PROPOSED S4.55(8) MODIFICATIONS LIST:

ISSUED FOR s4.55(8)
LODGMNT
NOT FOR CONSTRUCTION

VPM
9-11 VICTORIA PARADE, MANLY, NSW

DRAWING TITLE			PROJECT
FIFTH FLOOR PLAN			VPM
SCALE	STATUS	NUMBER	REVISION
1 : 100	s4.55 (8)	A1.07	A

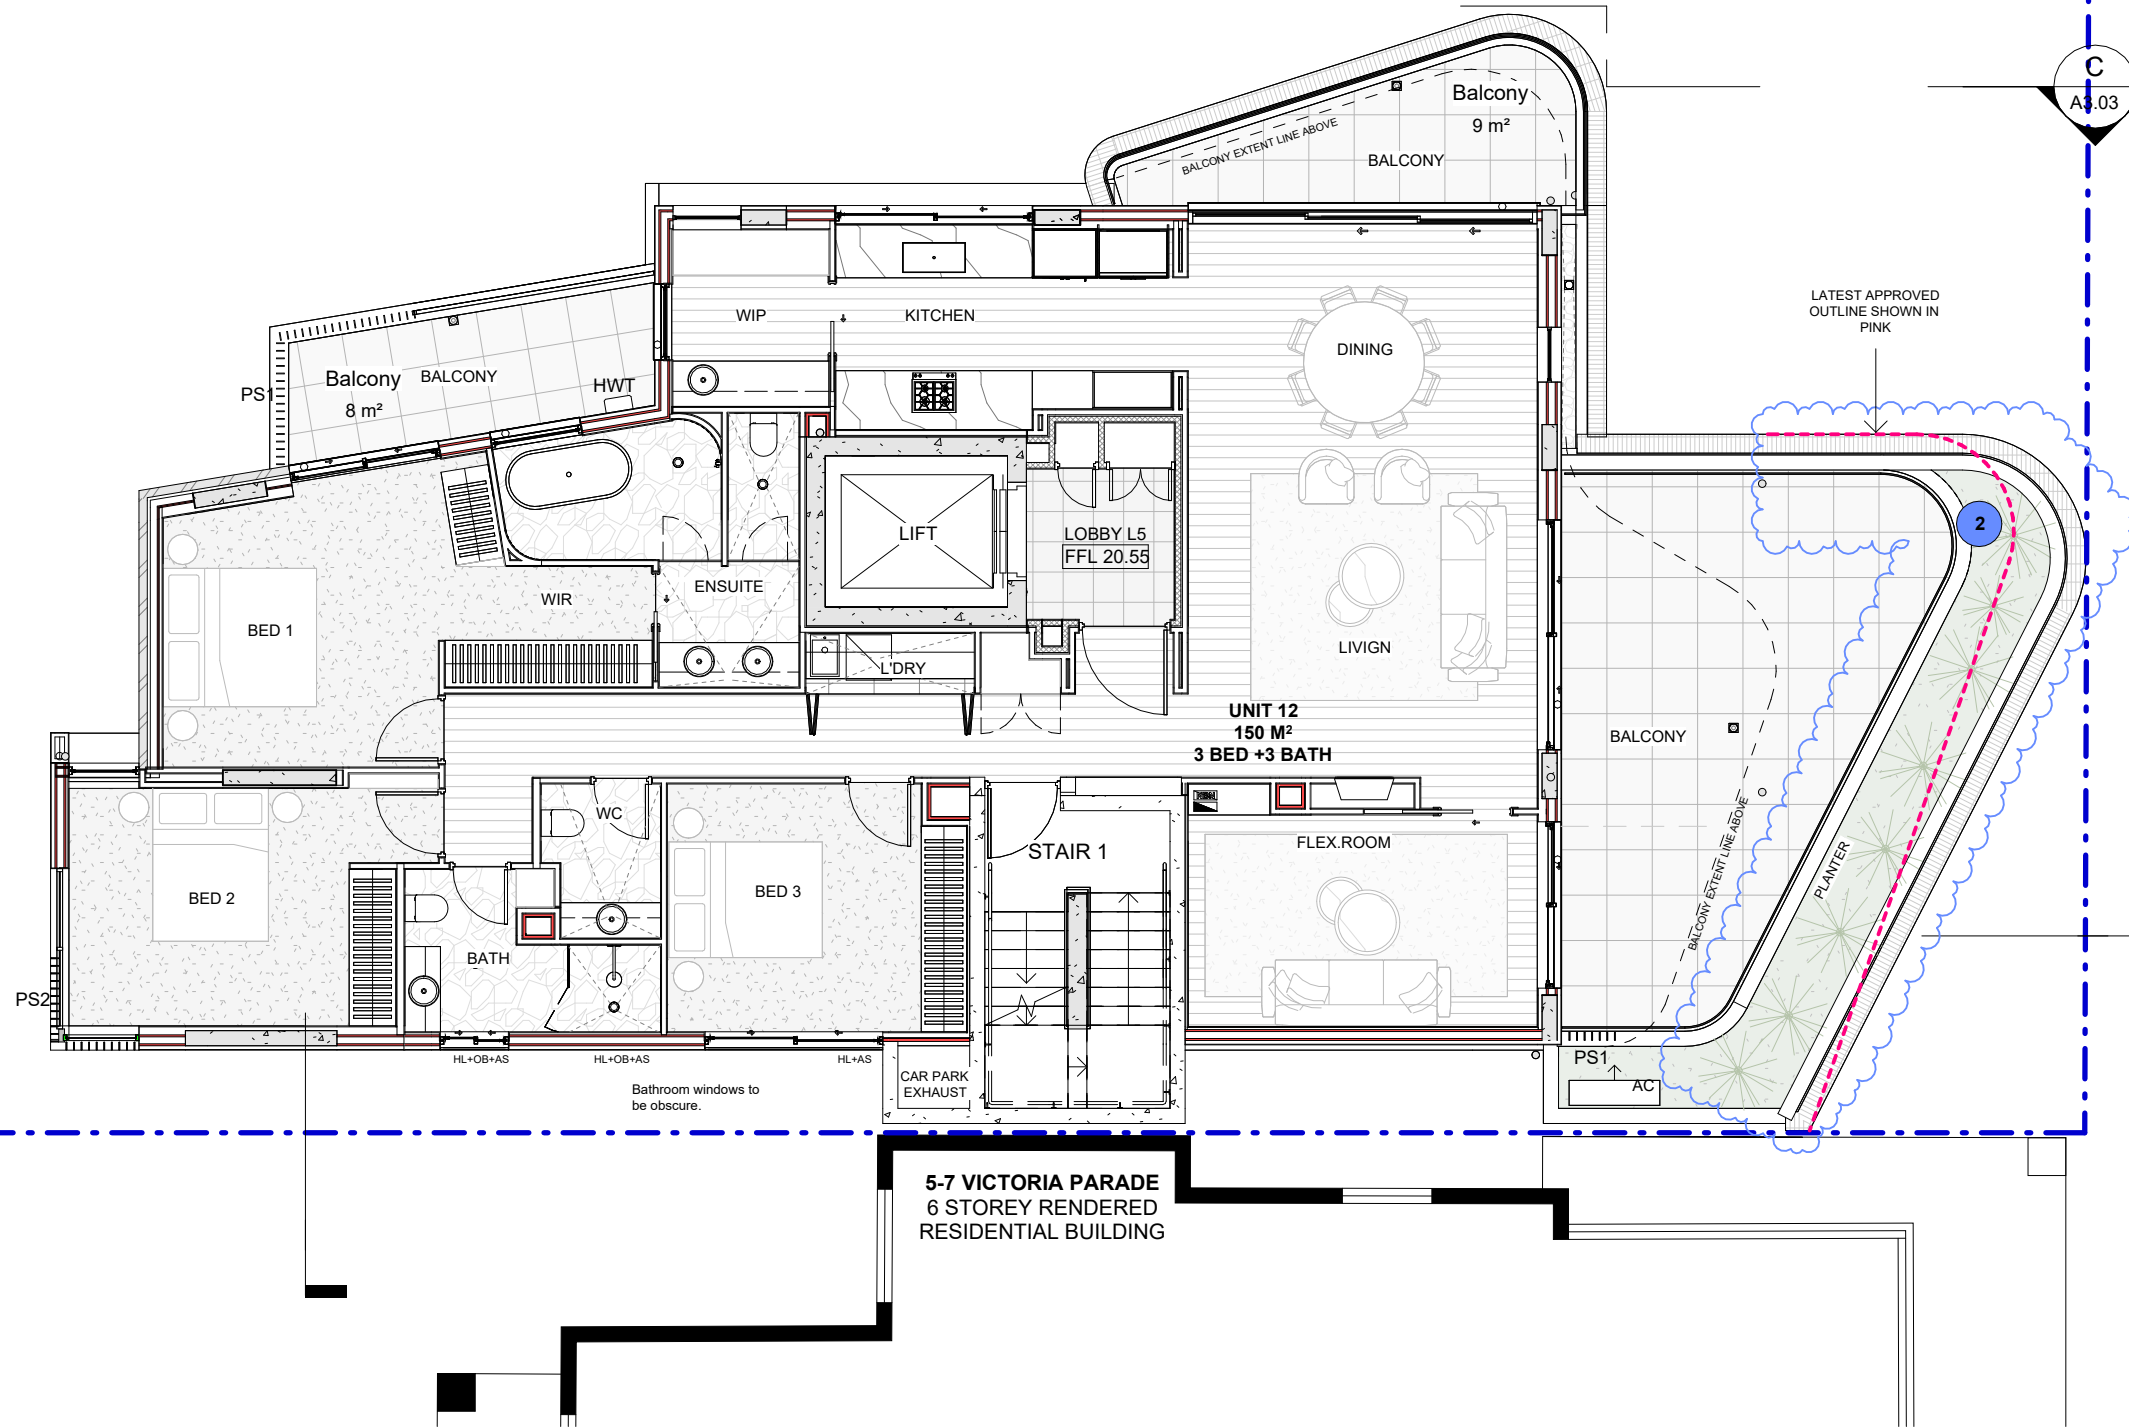
- Retail 1 on Ground floor has been pushed out to enhance the usable area and to suit new columns for balconies above.
- The front facade's angle has been adjusted to enlarge the front balconies and comply with ADG regulations of balcony size.

- Front balconies on level 1 and level 2 were extended to the north east to align with the approved balconies above to avoid looking 'top-heavy' and unbalanced.

- Level 4 brick wall shifted to align with adjacent brick walls.
- Cladding colour proposed to be off-white to visually lighten the bulk of the upper floors.

- Allocation of 1 bicycle space per unit in large storage cages in lieu of separate bicycle parking to satisfy the intention of condition 43D.
- Private roof terrace introduced to improve amenity of unit 14. The glass stair enclosure is not readily visible from the street and has no real impact on privacy, bulk or overshadowing.

- Increase in width of high-light windows to improve ventilation and natural lighting in the bedrooms with no privacy impacts.
- Minor adjustment to the GFA due to the above— still less than LEC approved FSR 3:1.

- Window heads have been lowered to 2.58m to fit services
